TITLE: \${PROJECTNAME}	
Document Number:	REV:
Date: \${CURRENT_DATE}	Sheet: \${#}/\${\$} / Title: v14

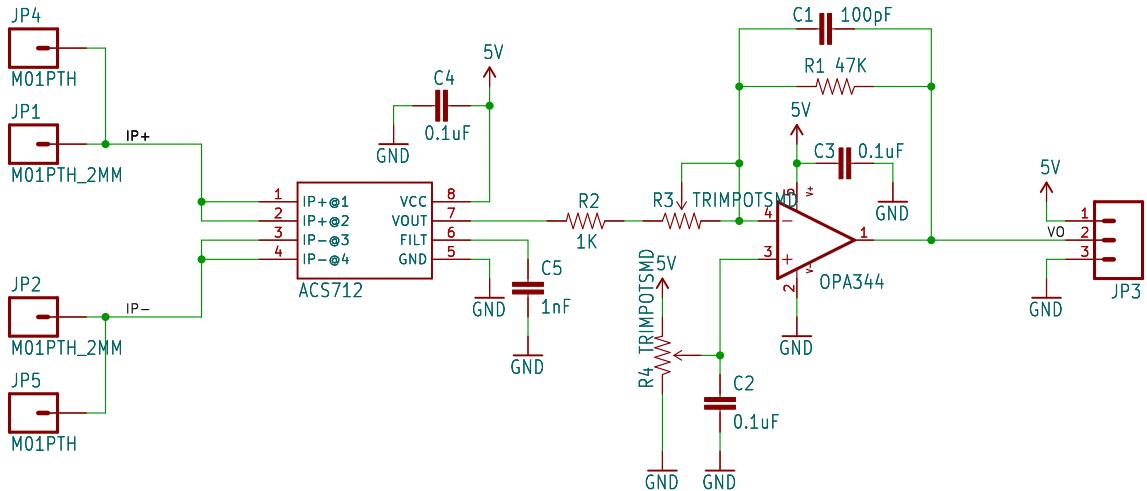
Changes to v13
-Updated library to increase anular rings and use new trimpot package

Changes to v14
-changed via drills to 20 mil to close up mask
